SHAKTOOLIK COMMUNITY HEALTH CLINIC

2003 CODE AND CONDITION SURVEY

March 1, 2004

**SHAKTOOLIK
COMMUNITY HEALTH CLINIC
2003 CODE AND CONDITION SURVEY REPORT**

BUILDING SECTION

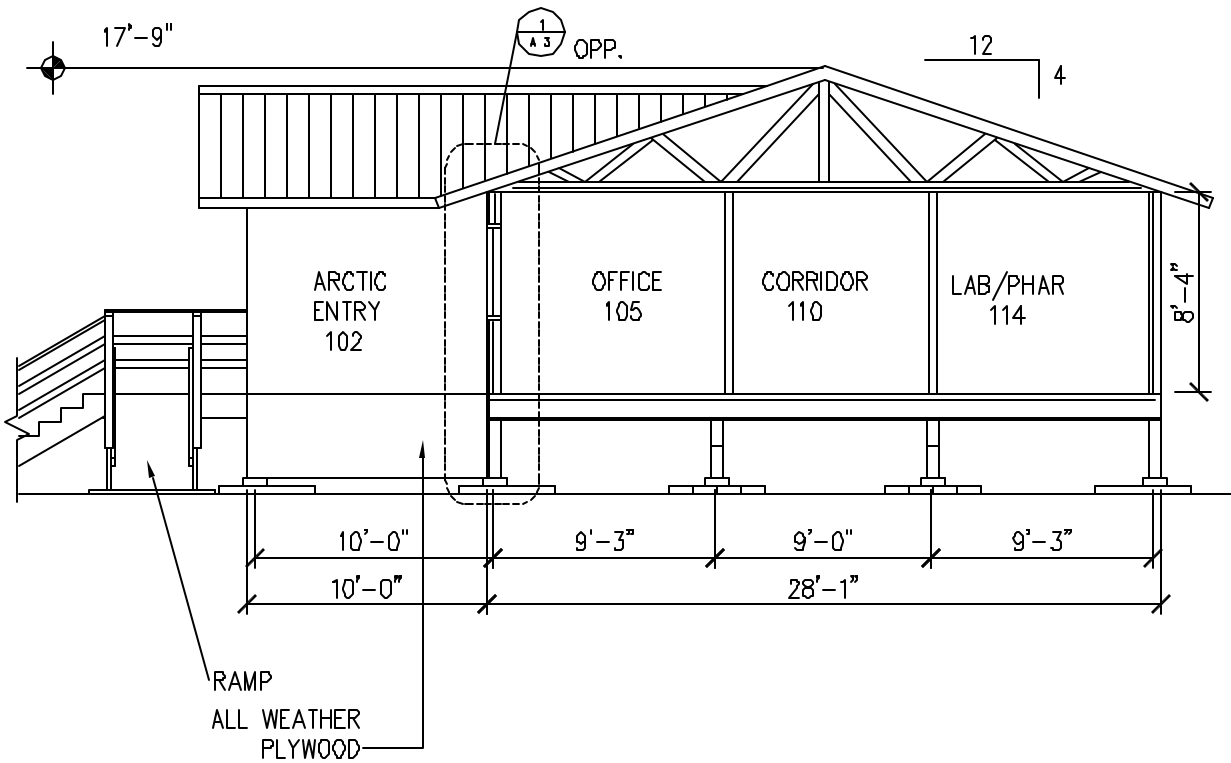
Foundation movement is evidenced in this clinic with separation occurring at the tops of walls and out of plumb door frames. In 2000, the clinic was still very new and this kind of movement in the first year was disturbing to the owner/tenants and to the review team. Over the last two years, the tenants have observed that the movement increases during the winter and is less prominent in the warmer months. It is important that this movement be monitored and procedures set up to level the building in response to ground movements to prevent structural damage.

Discipline	Sheet No.
A	4

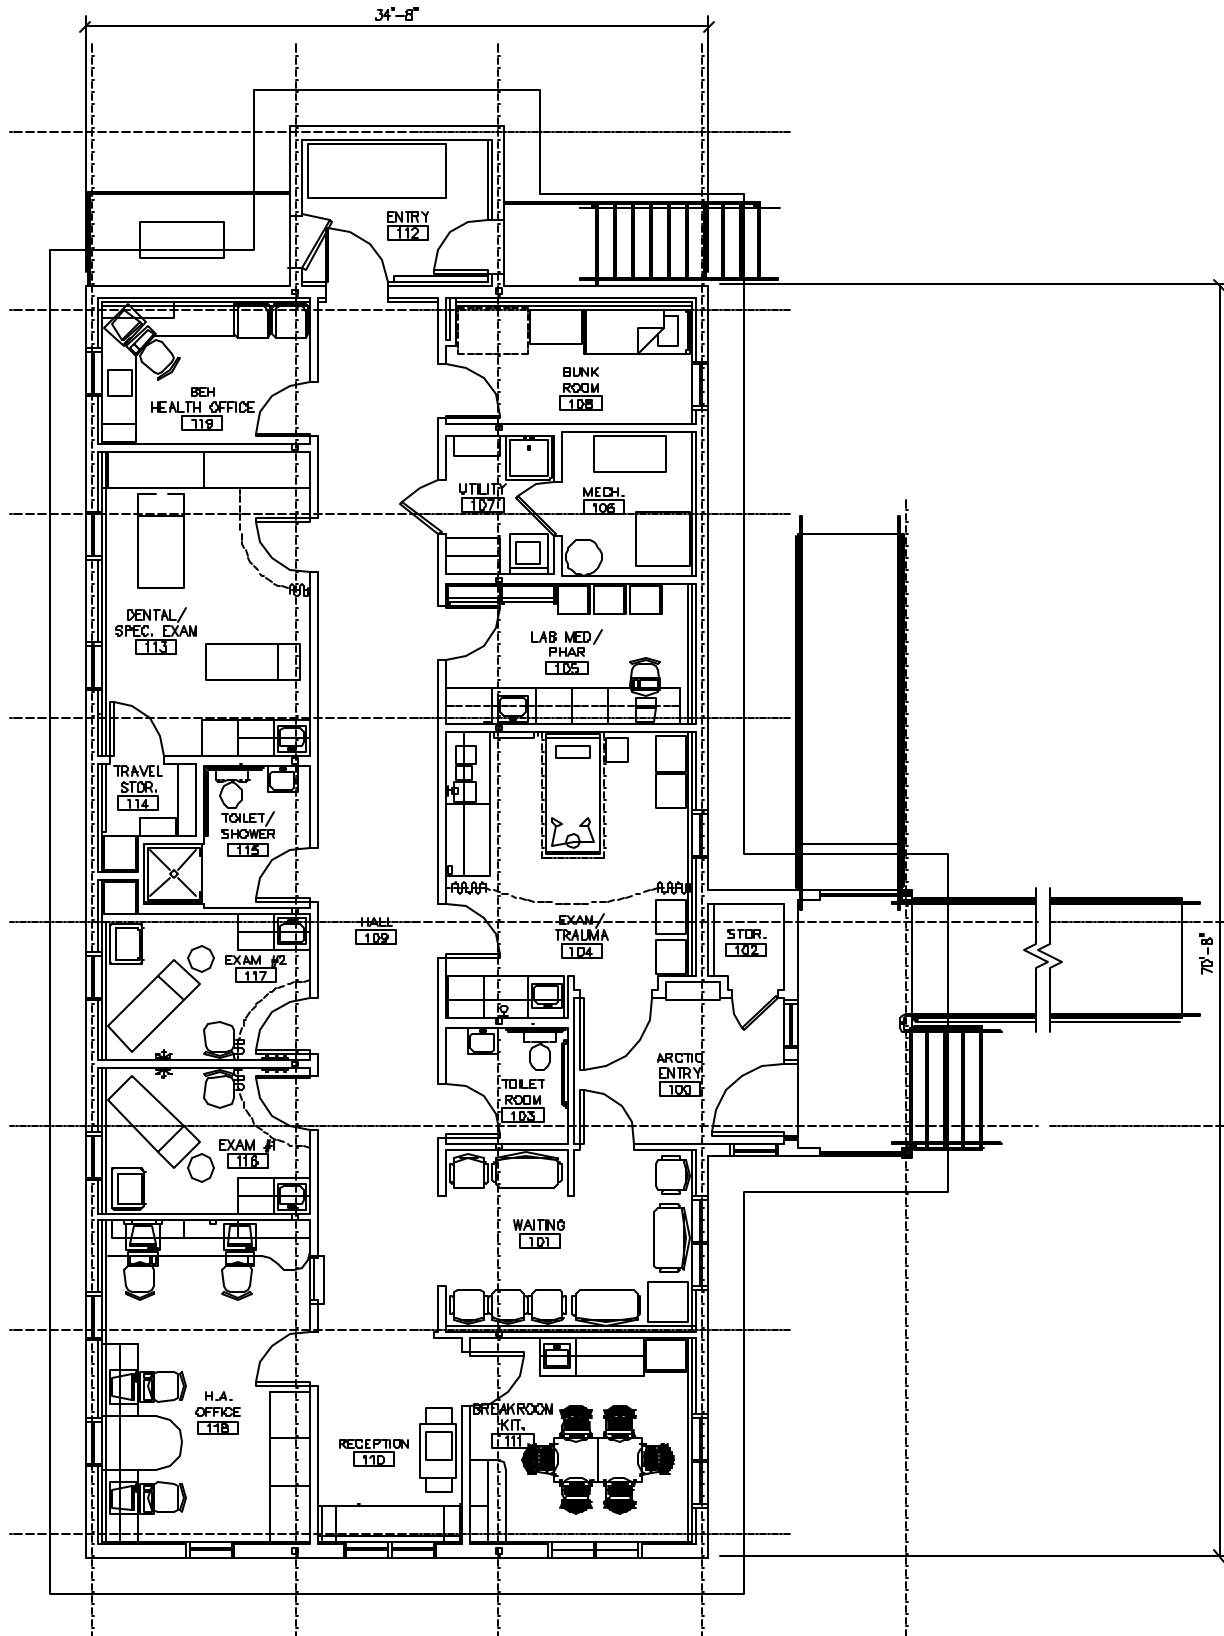
The building can be repaired as outlined in Part III Itemized Deficiencies. Although recently completed, this clinic has significant program inadequacies. Some minor interior modifications can be done to the existing clinic to maximize its programming needs. See attached document A4 for proposed modifications to the existing floor plan.

The changes proposed on this drawing are not intended to solve the program deficiencies noted, but rather, to make positive and significant improvements in the functional plan and to accommodate new modular furnishings. The modifications shown consist of the followings:

- Remove the wall between the two small offices to create a more congenial office environment and to make shared use of resources possible.
- Remodel reception/waiting area to accommodate dense filing system, new casework and a revised seating layout. Add low wall separating waiting from inner clinic area. This change keeps waiting patients separate from clinic area and under the observation of the receptionist while creating a work area at the end of the corridor.

- Add space in the corridor to accommodate a new janitor's room adjacent to the mechanical room. This will require a slight reduction in the size of the mechanical room, but the laundry will be moved out so the net space will still be adequate.

- Add larger doors to entries and to trauma room. (3'-6" width)
